APPLICATION NO.	FILING DATE	FIRST NAMED INVENTOR	ATTORNEY DOCKET NO.	CONFIRMATION NO.
09/873,144	06/01/2001	Erik K. Jurvis	25039A	3286
22889	7590	12/15/2003	EXAMINER	
OWENS CORNING			HORTON, YVONNE MICHELE	
2790 COLUMBUS ROAD			ART UNIT	
GRANVILLE, OH 43023			PAPER NUMBER

Office Action Summary

DETAILED ACTION

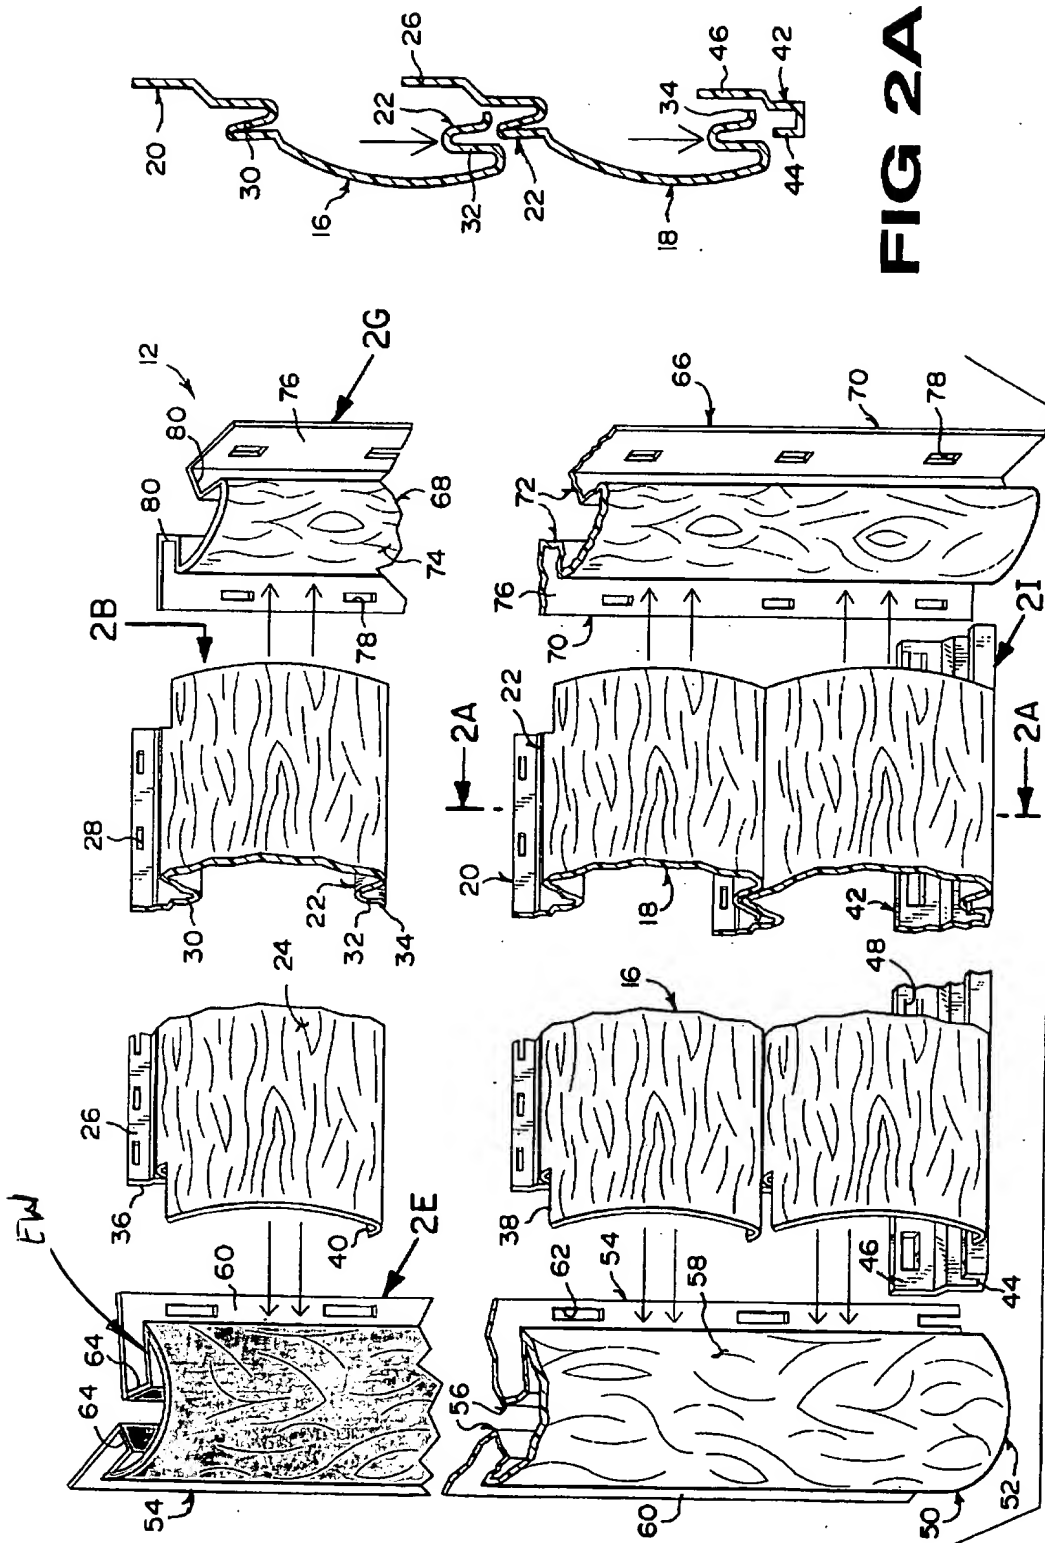
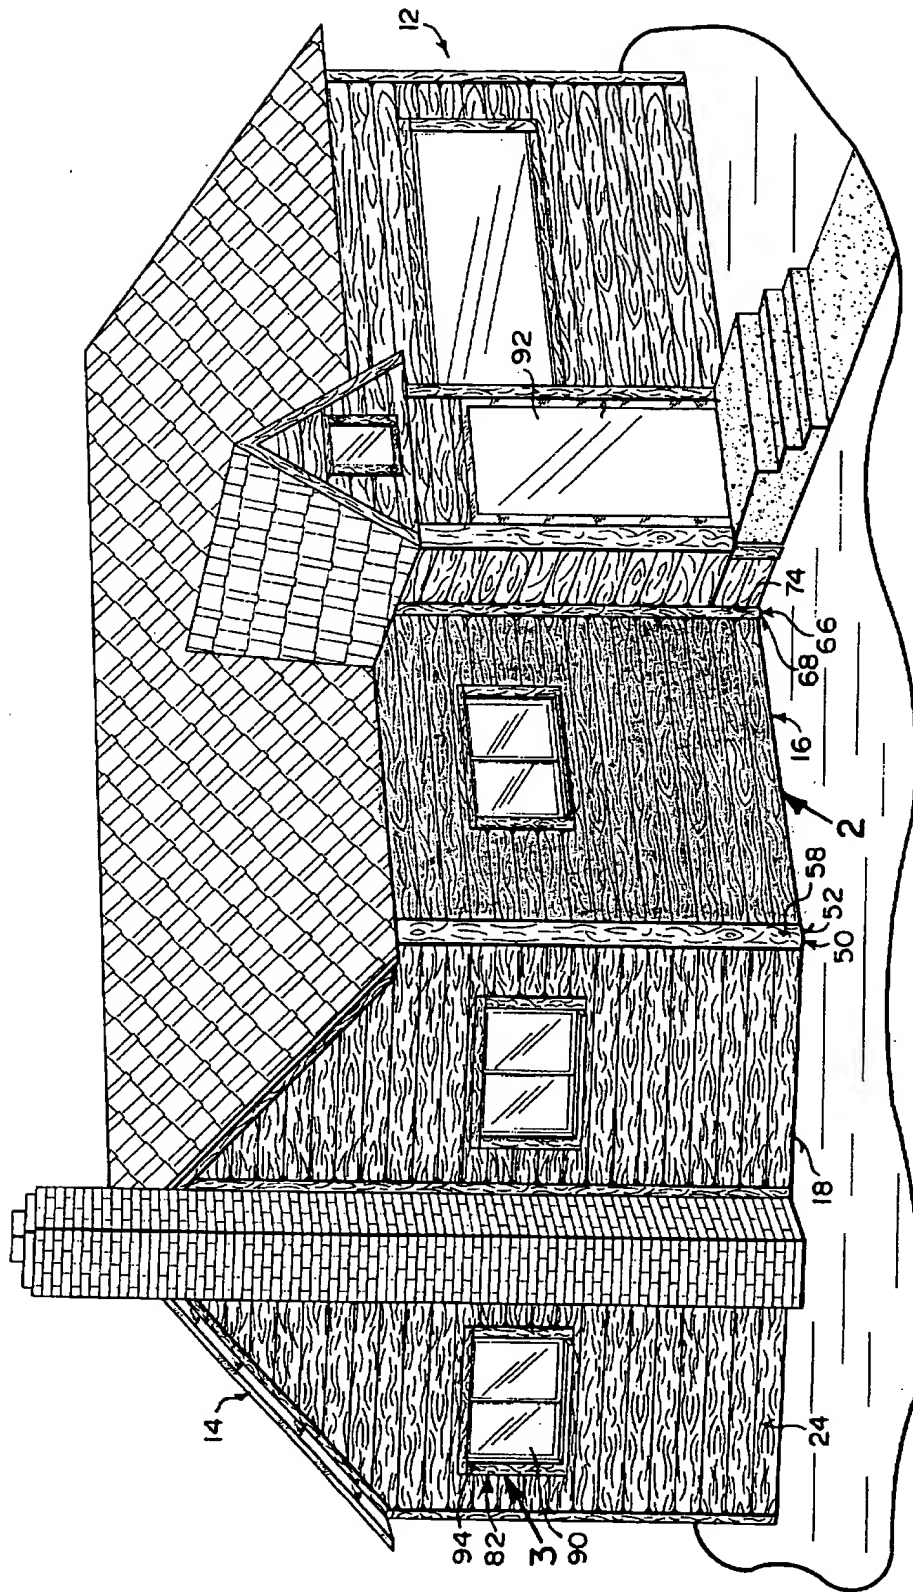
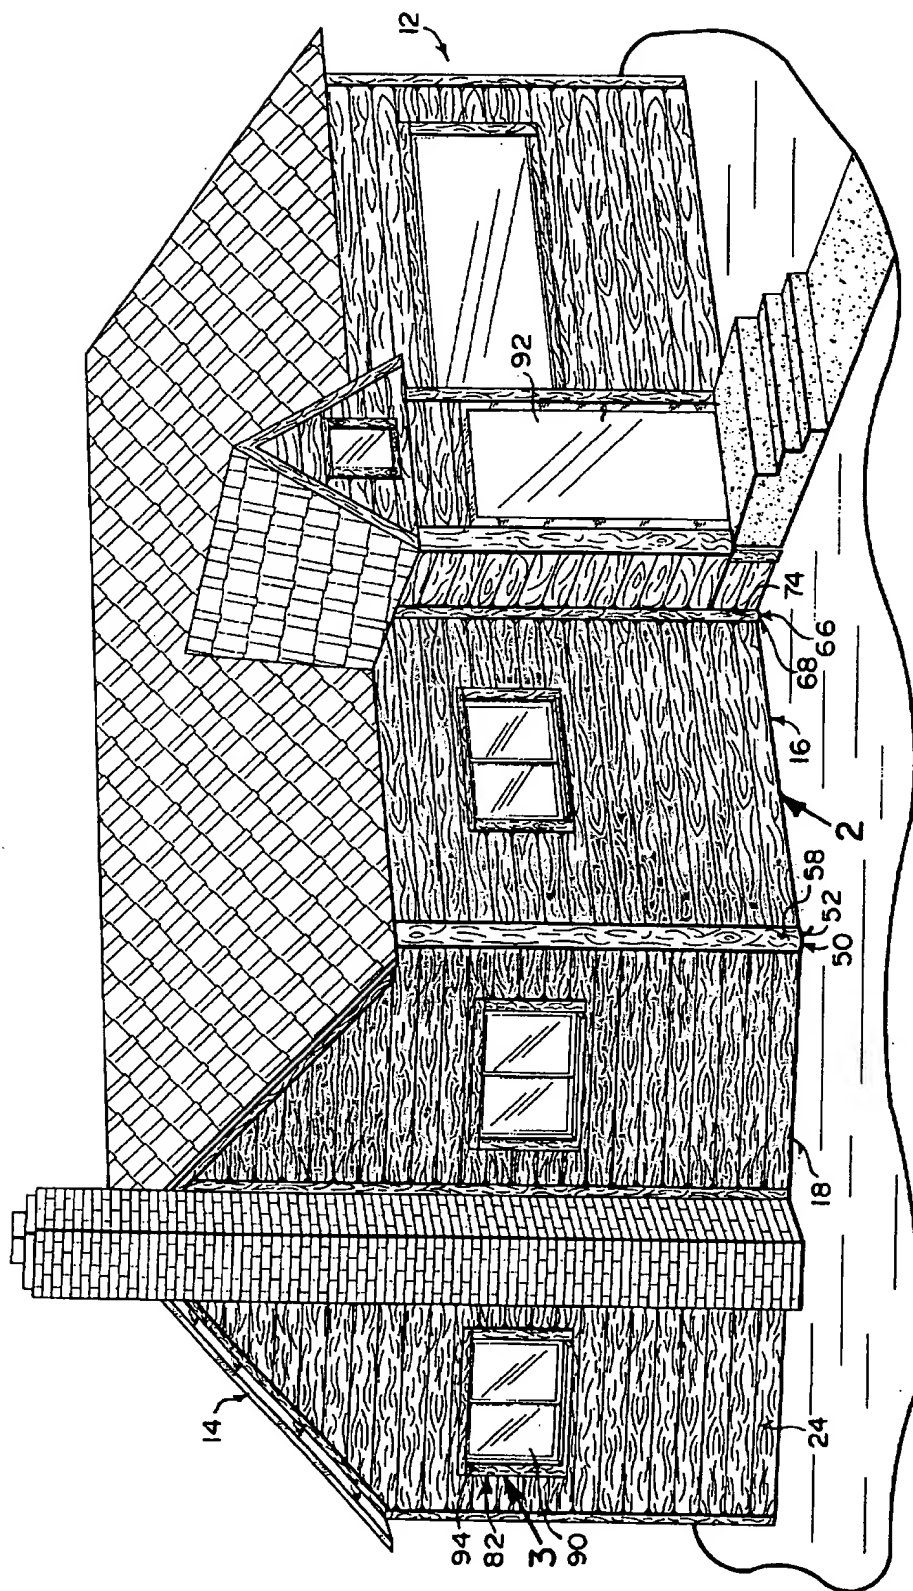
4. Considering objective evidence present in the application indicating obviousness or nonobviousness.
8. Claims 1-4,6,7 and 9-10 are rejected under 35 U.S.C. 102(b) as anticipated by or, in the alternative, under 35 U.S.C. 103(a) as obvious over US Patent #5,694,728 to HEATH, Jr. et al. In claims 1 and 7, the applicant is reminded that “substantially” clearly implies that something less than the exact amount can be required. HEATH, Jr. et al. discloses the use of a component (50) for receiving a plurality of extending siding strips (16) wherein the component (50) includes an elongate body (52) for abutting against a planar wall, column 5, lines 2-5, first and second (64) receivers “substantially” 180 degrees in opposite directions, see figure 2, each for receiving a portion a portion of the horizontally extending siding strips (16), and an outwardly bowed portion (colored red). Each receiver (64) is “substantially” U-shaped and includes a first wall (colored green) for at least partially covering the end of the siding strip (16), an end wall (EW) connected to the first wall (colored green), and a fastener receiving portion (60) for abutting the wall of the building (14), column 5, lines 2-5, see the marked attachment. Although the first and second receivers of the component of HEATH, Jr. et al. do not extend at exactly or precisely 180 degrees, they do extend “substantially” at 180 degrees in opposing directions. Hence, it would have been obvious to one having ordinary skill in the art at the time the invention was made that the device of HEATH, Jr. et al. include receivers that extend “substantially” at 180 degrees in opposing directions. Regarding claim 2, as stated above, the system of HEATH, Jr. et al. includes integral fastener receiving portions (60). In reference to claims 3 and 4, the outwardly bowed portion (colored red) of HEATH, Jr. et al. is integrally connected to a portion of each

receiver (64) and includes indicia (58), column 5, lines 11-13, that stimulates the appearance of the system. Regarding claim 6, as stated earlier, each receiver includes an end wall (EW), see the marked attachment. In reference to claim 7, the end walls (EW) are “substantially” parallel and are spaced apart. Regarding claim 9, the first wall (colored green) of each receiver (64) is indirectly integrally connected to an end of the outwardly bowed portion (colored red) through the end wall (EW); wherein, the outwardly bowed portion (colored red) simulates the appearance of a log, column 5, lines 11-13. In reference to claim 10, the fastener receiving portion (60) is elongated relative to the first wall (colored green) of the corresponding receiver (64).

9. Claims 11-13 and 15-16 are rejected under 35 U.S.C. 102(b) as anticipated by or, in the alternative, under 35 U.S.C. 103(a) as obvious over US Patent #5,694,728 to HEATH, Jr. et al. In claims 11-13, the applicant is reminded that “substantially” clearly implies that something less than the exact amount can be required. HEATH, Jr. et al. discloses the use of a vertically extending component (50) for receiving at least a first and at least a second “substantially” horizontally extending siding strips (16) wherein the component (50) includes an elongate body (52) for abutting against a planar wall, column 5, lines 2-5, first and second (64) receivers “substantially” 180 degrees in opposite directions, see figure 2, each for receiving a portion a portion of the horizontally extending siding strips (16), and an outwardly bowed portion (colored red). Each receiver (64) is “substantially” U-shaped and includes a first wall (colored green) for at least partially covering the end of the siding strip (16), an end wall (EW) connected to the first wall (colored green), and a fastener receiving portion (60) for abutting the wall of the building (14), column 5, lines 2-5, see the marked attachment. Although the first and second receivers of

the component of HEATH, Jr. et al. do not extend at exactly or precisely 180 degrees, they do extend “substantially” at 180 degrees in opposing directions. Hence, it would have been obvious to one having ordinary skill in the art at the time the invention was made that the device of HEATH, Jr. et al. include receivers that extend “substantially” at 180 degrees in opposing directions. Regarding claim 12, the first and second siding strips (16) are positioned “substantially” in the same vertical plane (colored blue), see the marked attachment. In reference to claim 13, the first and second siding strips (16) are positioned “substantially” in the same horizontal plane (colored yellow), see the marked attachment. Regarding claim 15, the system of HEATH, Jr. et al. further includes at least one fastener (unlabeled), column 5, line 2-4, for fastening each fastener receiving portion (60) to the wall of a building (14). Regarding claim 16, the first wall (colored green) of each receiver (64) is indirectly integrally connected to and end of the outwardly bowed portion (colored red) through the end wall (EW); wherein, the outwardly bowed portion (colored red) simulates the appearance of a log, column 5, lines 11-13.

10. Claim 17 is rejected under 35 U.S.C. 102(b) as anticipated by or, in the alternative, under 35 U.S.C. 103(a) as obvious over US Patent #5,694,728 to HEATH, Jr. et al. The applicant is reminded that “substantially” clearly implies that something less than the exact amount can be required. The structure of HEATH, Jr. et al. inherently discloses the method for installing a plurality of siding members (16) including the steps of providing an elongated component (50) having an outwardly bowed body (colored red), see the marked attachment, first and second receivers (64) extending at “substantially” 180 degrees in opposing directions, and a first wall (colored green), see the marked attachment; vertically orienting the elongated component (50);

inserting the first end of the plurality of siding members (16) into one of a first or second receiver (64); inserting a second end of the plurality of siding members (16) into one of a first or second receiver (64); and affixing the siding members (16) to the wall (unlabeled) of a building (14), column 5, lines 2-5; wherein each receiver (64) includes a fastener receiving section (60) and the steps further include placing at least one fastener through the fastener receiving section (60), column 5, lines 11-13.
